Re: Semi-Annual Report Uranerz Energy Corporation Nichols Ranch ISR Project, SUA-1597

Revised pages to the license application are enclosed in accordance with SUA-1597 License Condition 9.4E. An index of change has been included to guide insertion into the license application.

**Nichols Ranch ISR Project
License Number SUA-1597
Docket No.40-9067**

Semi-Annual Report

FIGURE 3-9B
HEADER HOUSE PIPING AND INSTRUMENTATION (TYPICAL)

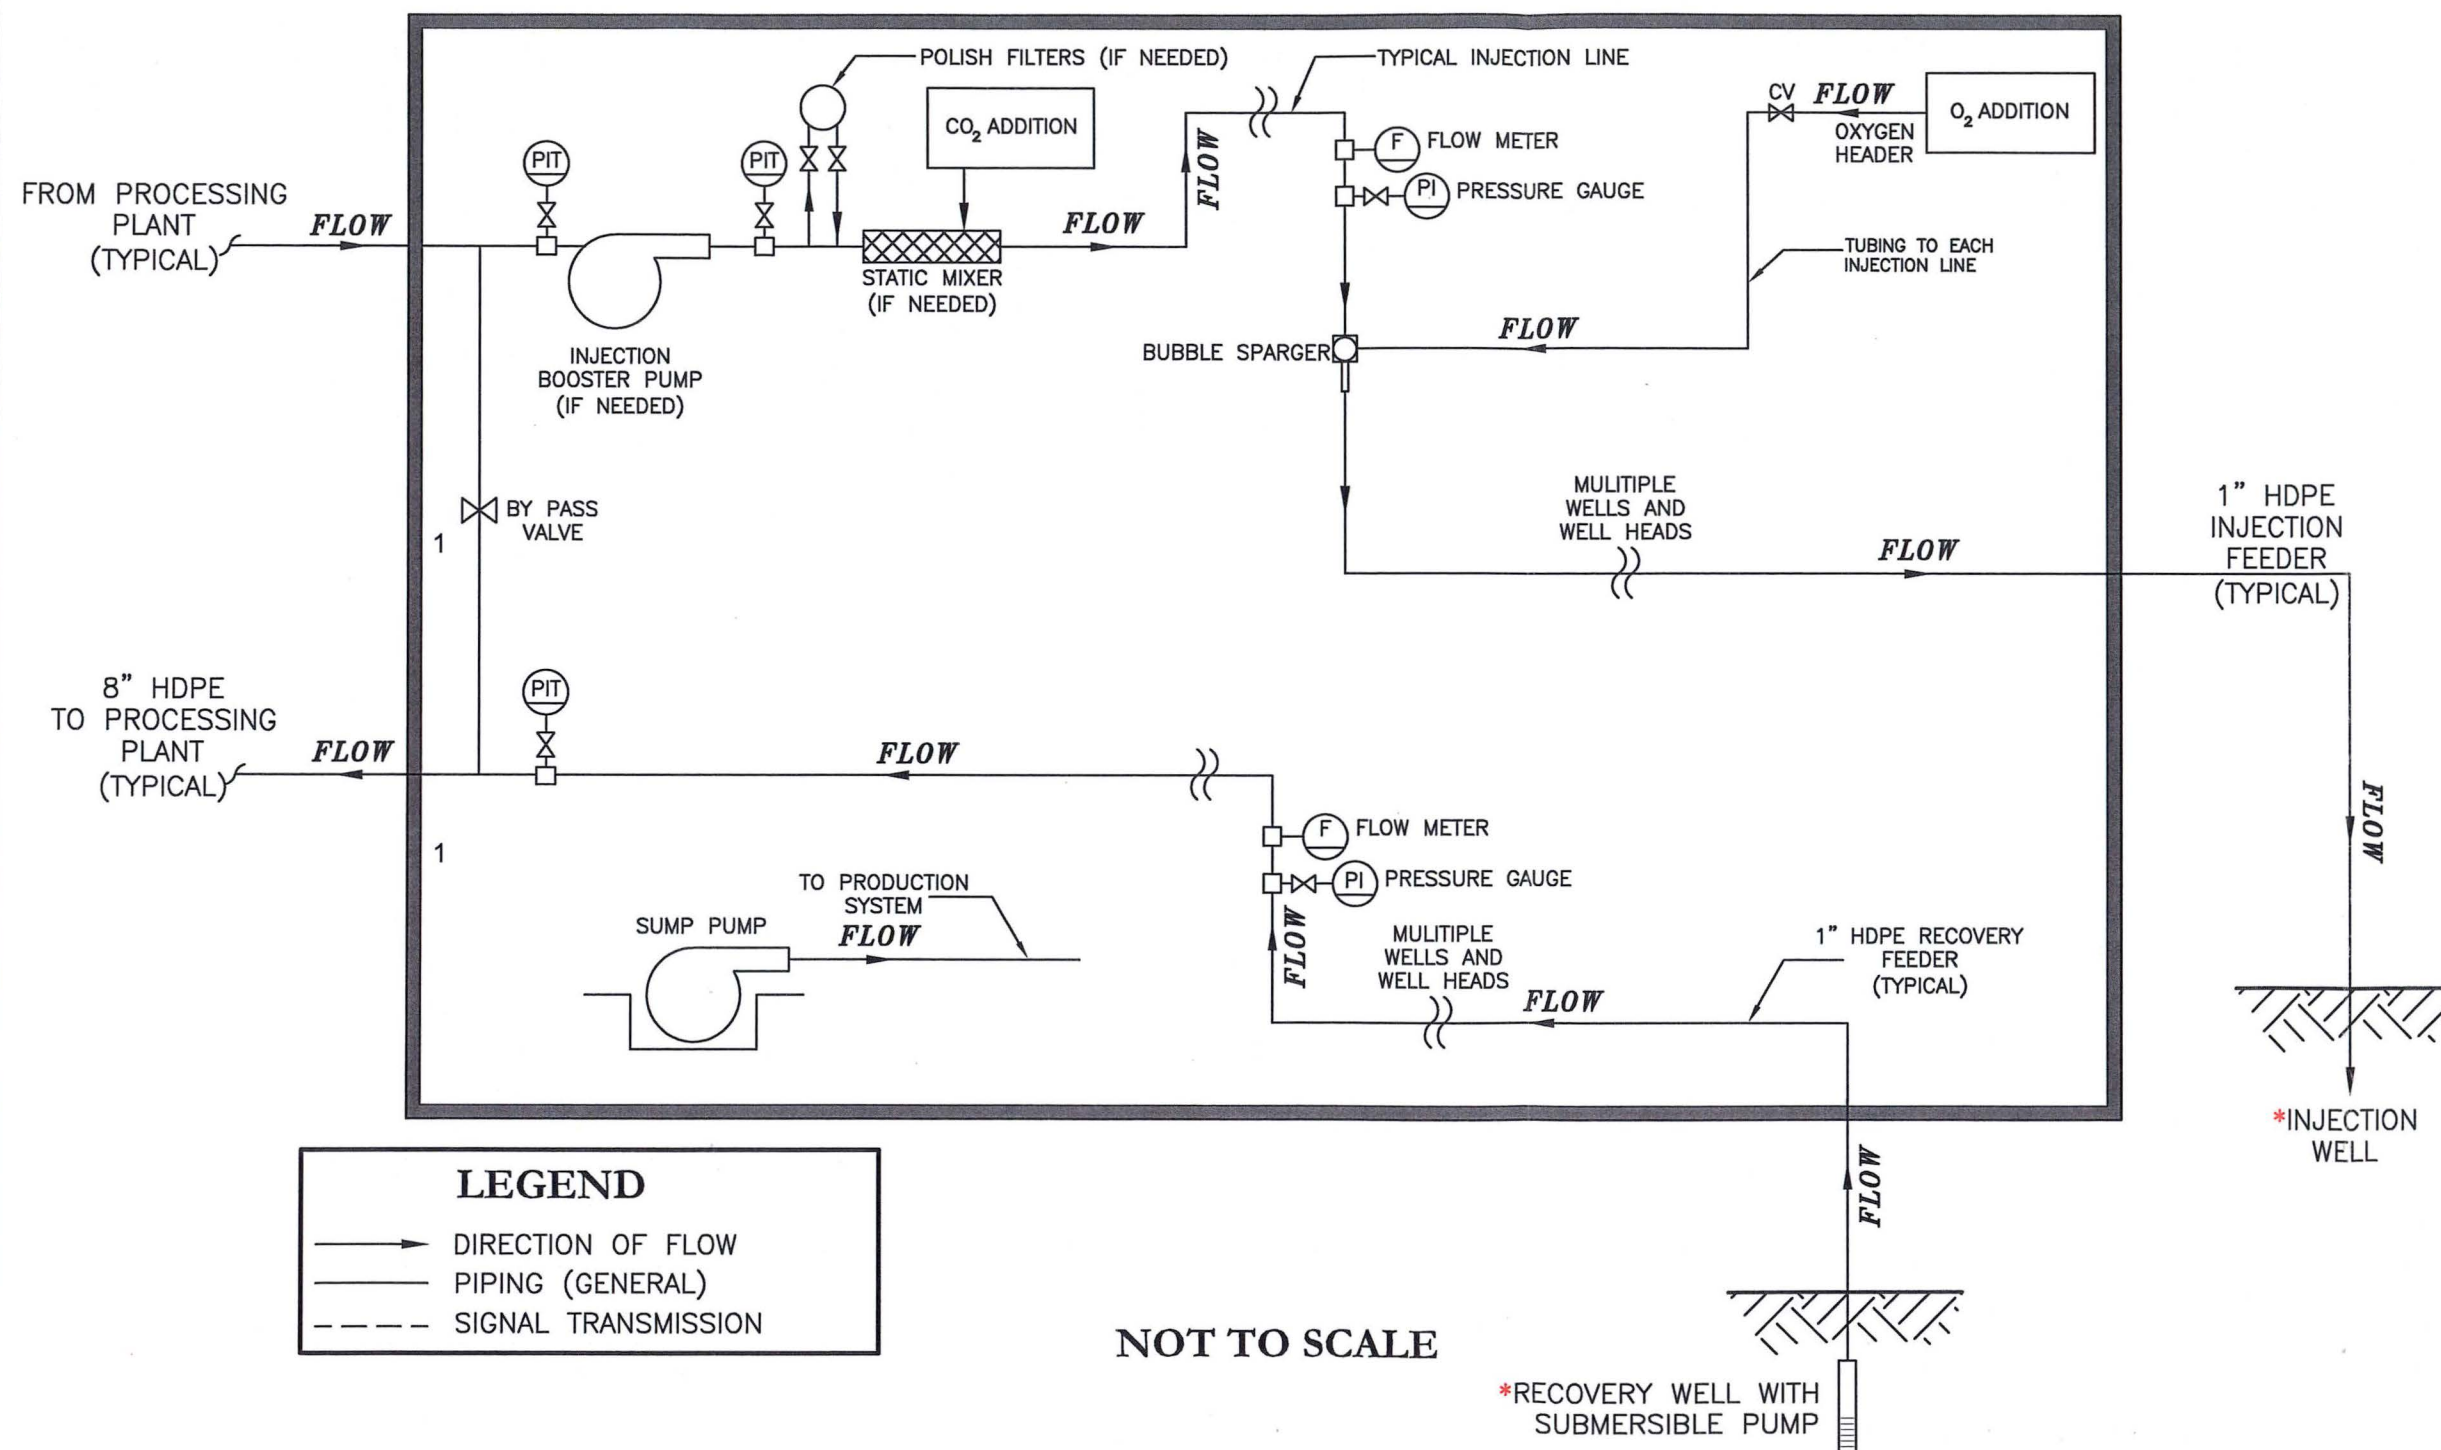
Figure 3-8B Hank Unit Proposed Monitor Well Locations	Map Pocket
Figure 3-9 Typical 5-Spot Well Pattern.....	Map Pocket
Figure 3-9A Header House Details	Map Pocket
Figure 3-9B Header House Ground Level <i>Header House Piping and Instrumentation</i>	Map Pocket
Figure 3-9C Header House Piping and Instrumentation	Map Pocket
Figure 3-10 Nichols Ranch Unit Production Areas	Map Pocket

Delete
Figure
3-9C
altogether

FIGURE 3-9C Figure 3-9B
HEADER HOUSE PIPING AND INSTRUMENTATION (Typical)

Figure 3-8B Hank Unit Proposed Monitor Well Locations	Map Pocket
Figure 3-9 Typical 5-Spot Well Pattern.....	Map Pocket
Figure 3-9A Header House Details	Map Pocket
Figure 3-9B Header House Piping and Instrumentation	Map Pocket
Figure 3-10 Nichols Ranch Unit Production Areas	Map Pocket

FIGURE 5-1 URANERZ ORGANIZATION

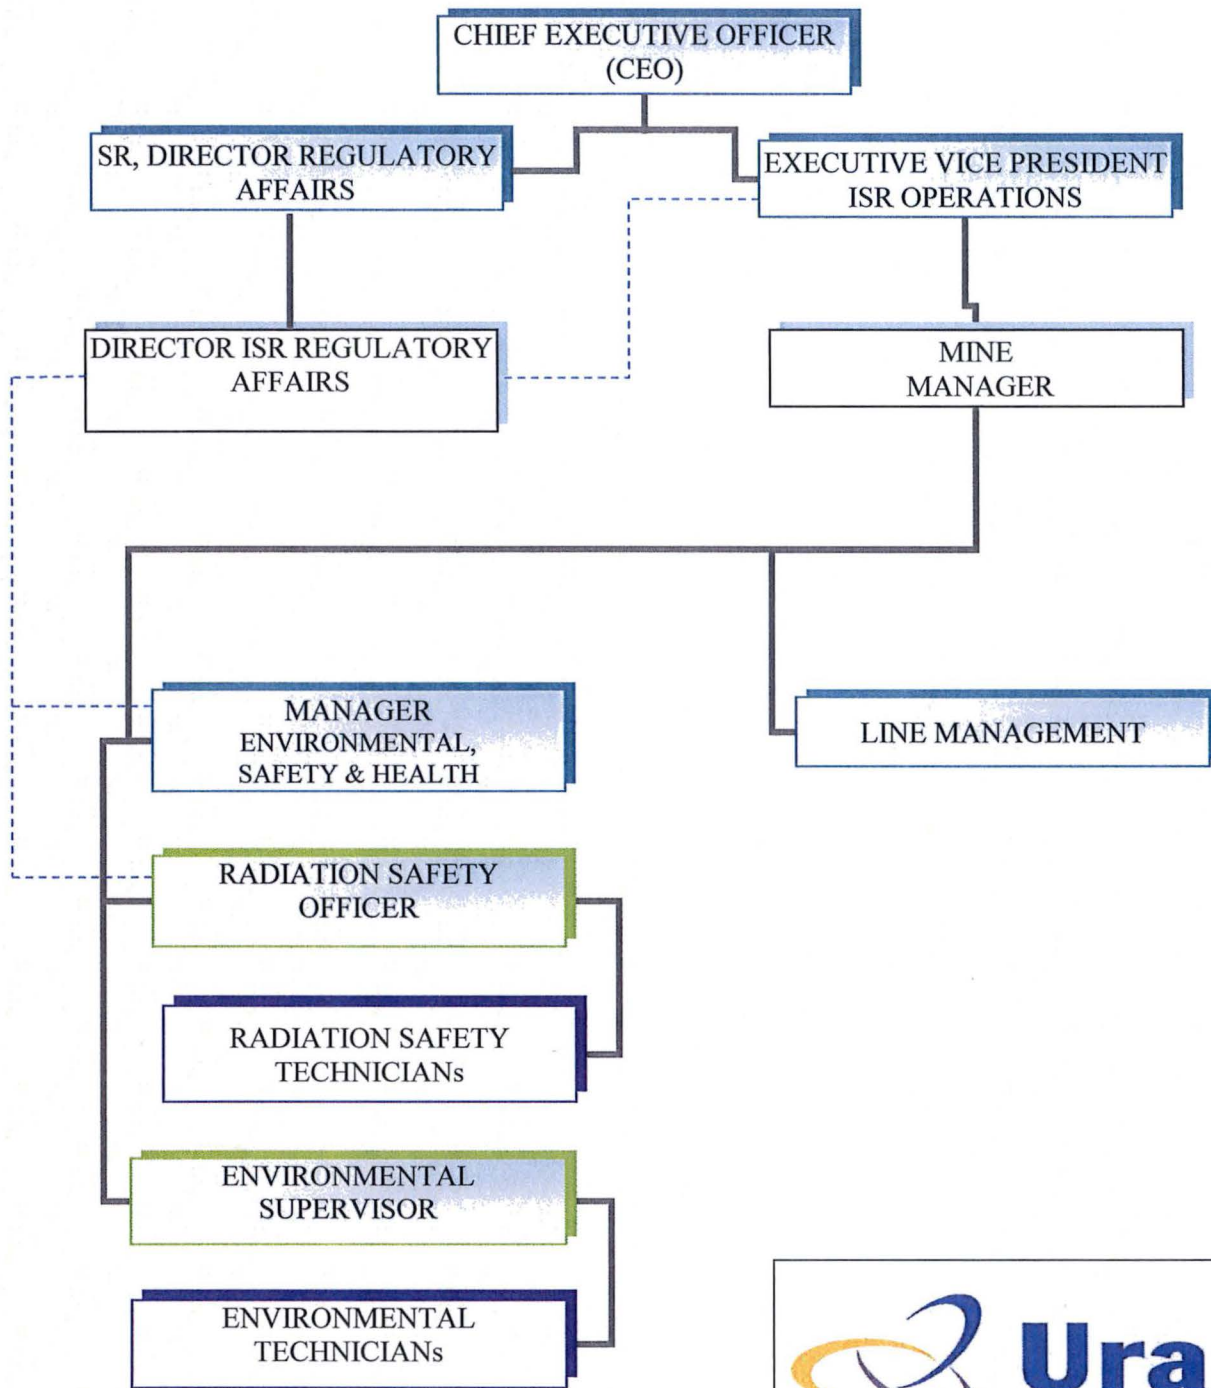
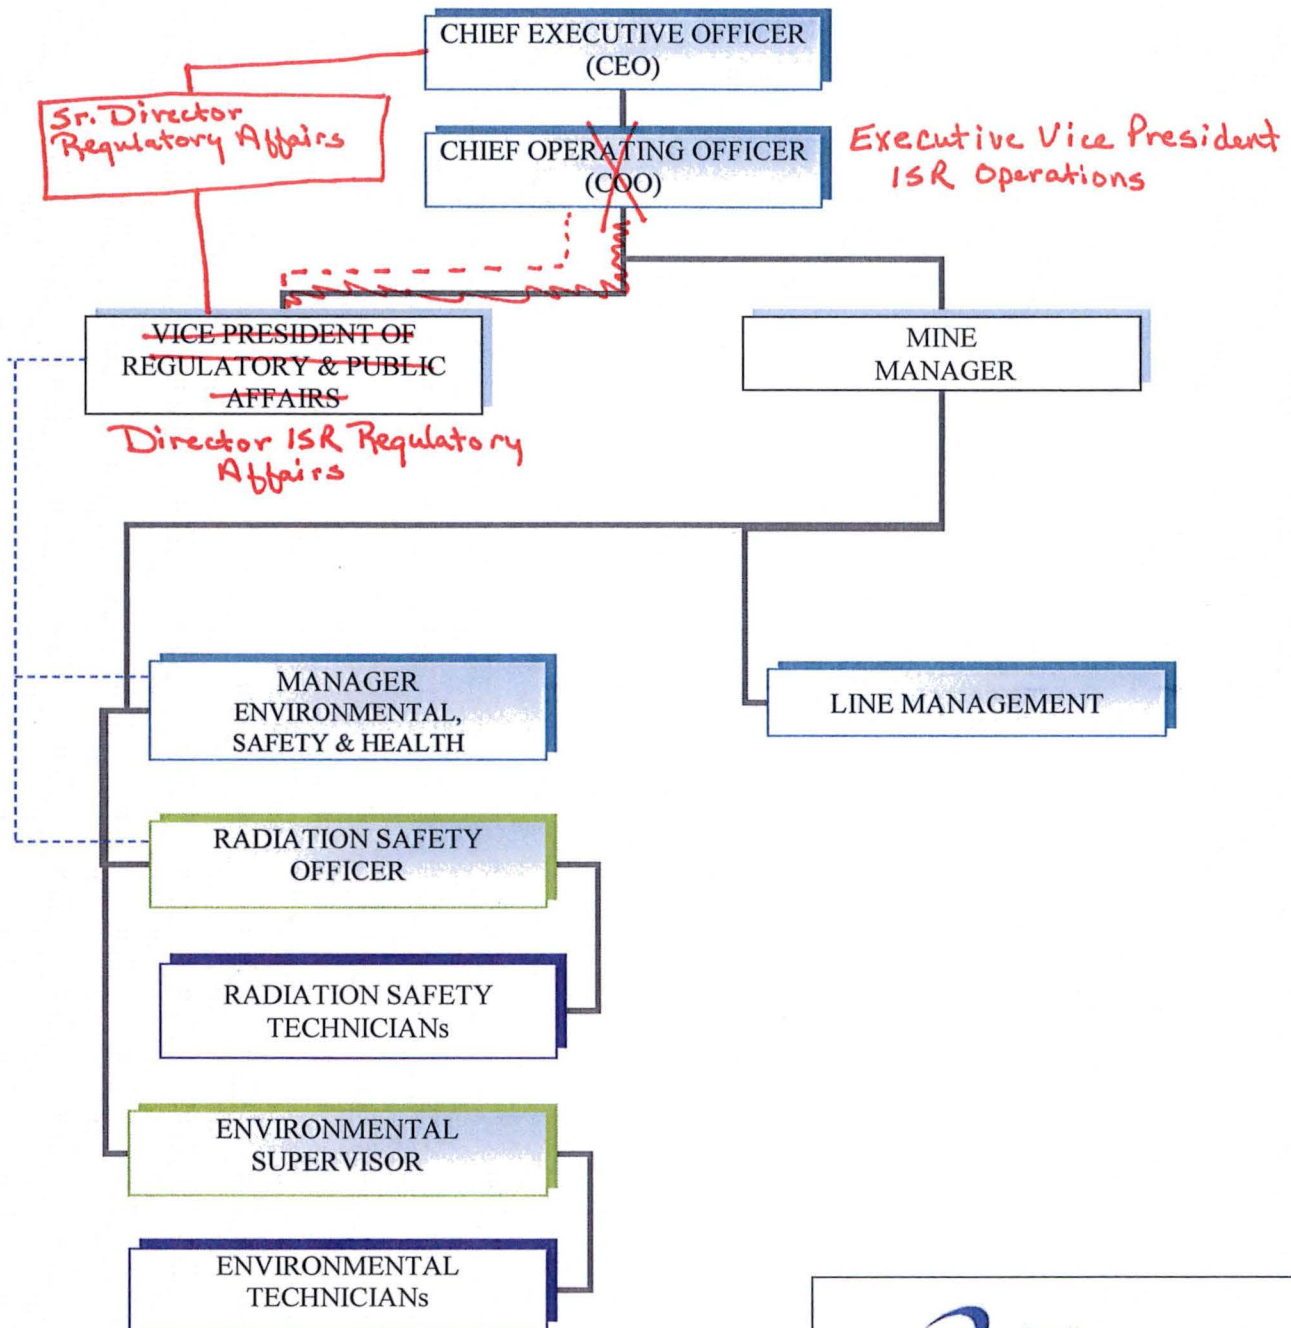
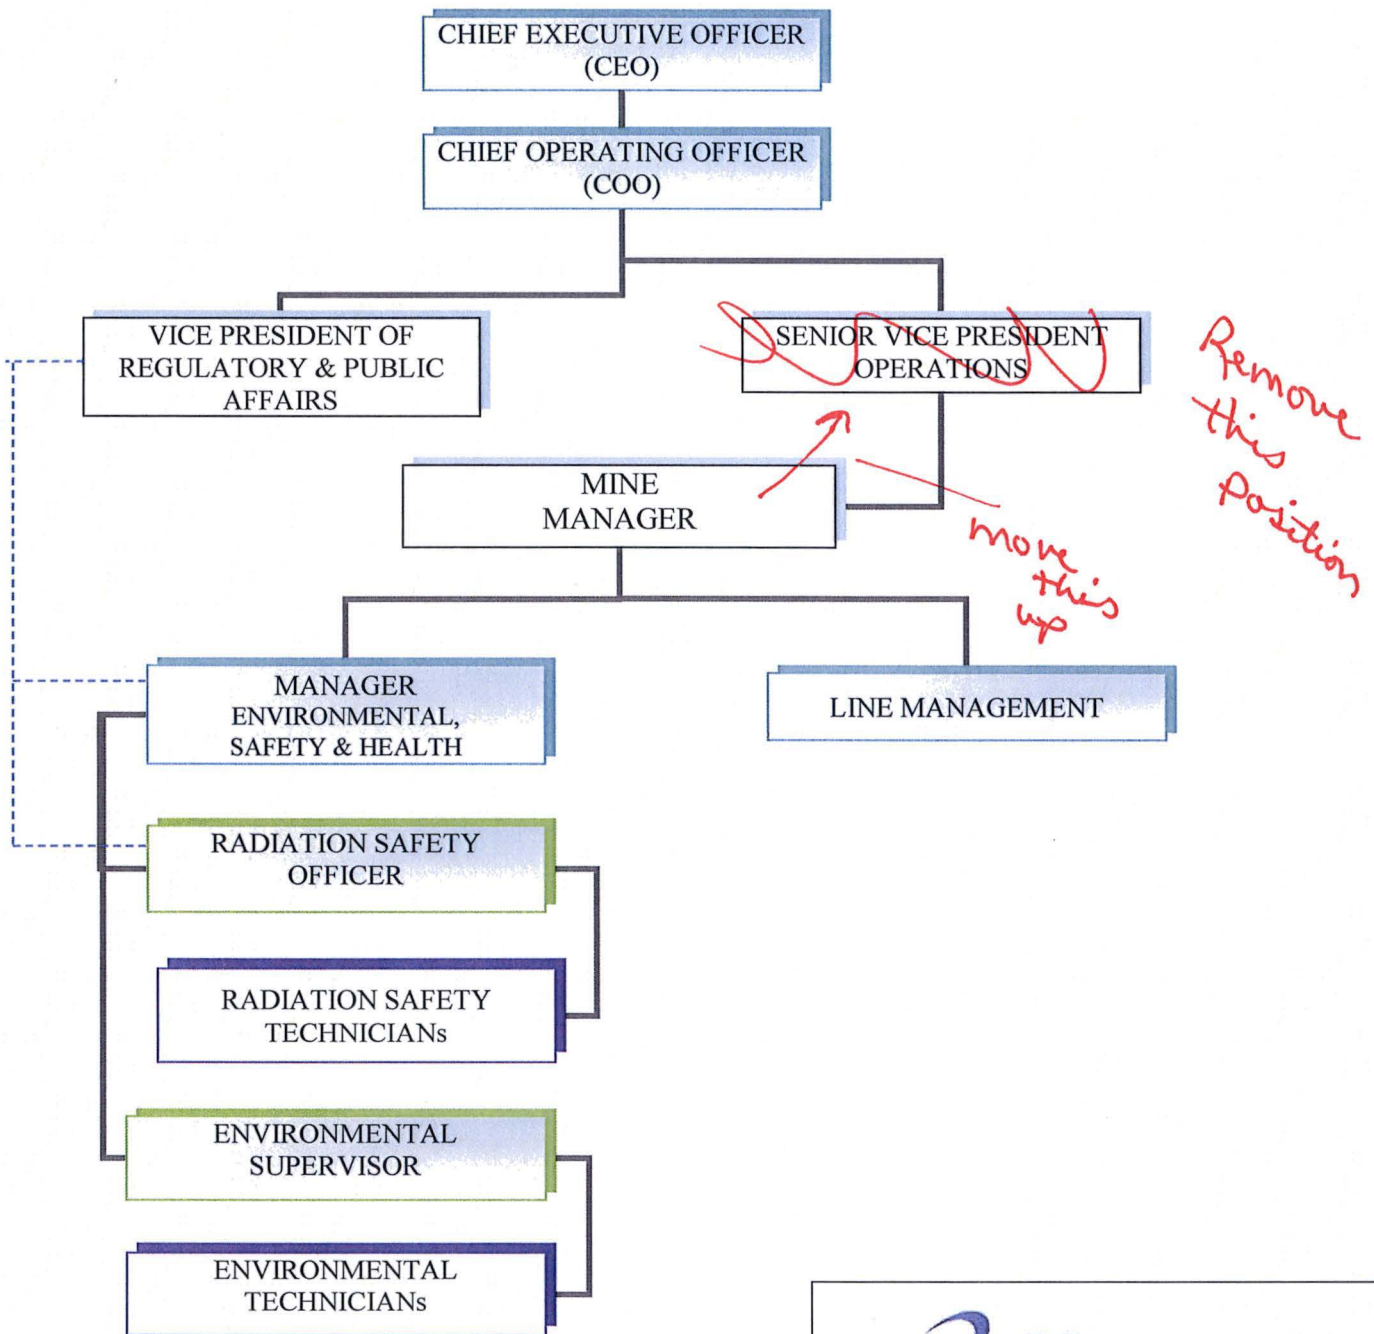
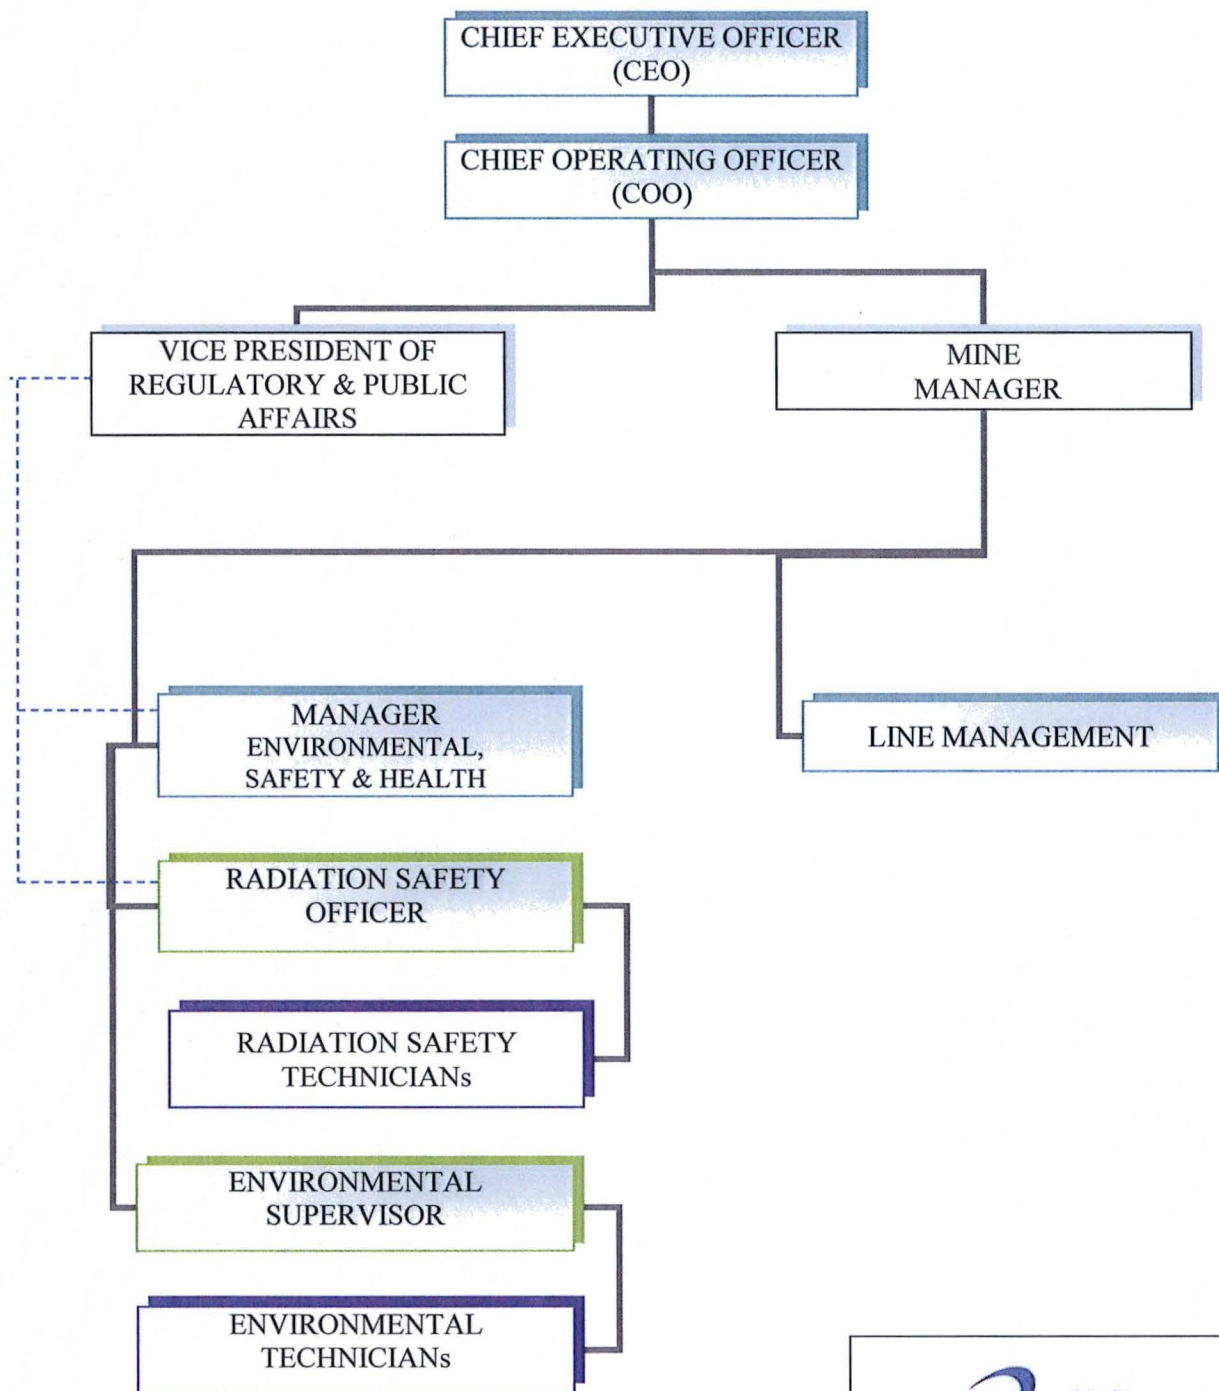
The Mine Manager reports directly to the ~~COO~~ EVP. All site operations, maintenance, construction, environmental health and safety, and support groups report to the Mine Manager. The Mine Manager is authorized to implement immediately any action to correct or prevent hazards. The Mine Manager has the responsibility and the authority to suspend, postpone, or modify, immediately if necessary, any activity that is determined to be a threat to employee or public health, the environment, or potentially a violation of state or federal regulations.

~~The Senior Vice President, Operations reports directly to the COO. The Senior Vice President, Operations is responsible for all production activity at the site. In addition to production activities, the Senior Vice President, Operations is also responsible for implementation of industrial and radiation safety, and environmental protection programs associated with operations. The Senior Vice President, Operations directly supervises the Mine Manager.~~

The Mine Manager reports directly to the ~~Senior Vice President, Operations~~ COO. All site operations, maintenance, construction, environmental health and safety, and support groups report to the Mine Manager. The Mine Manager is authorized to implement immediately any action to correct or prevent hazards. The Mine Manager has the responsibility and the authority to suspend, postpone, or modify, immediately if necessary, any activity that is determined to be a threat to employee or public health, the environment, or potentially a violation of state or federal regulations.
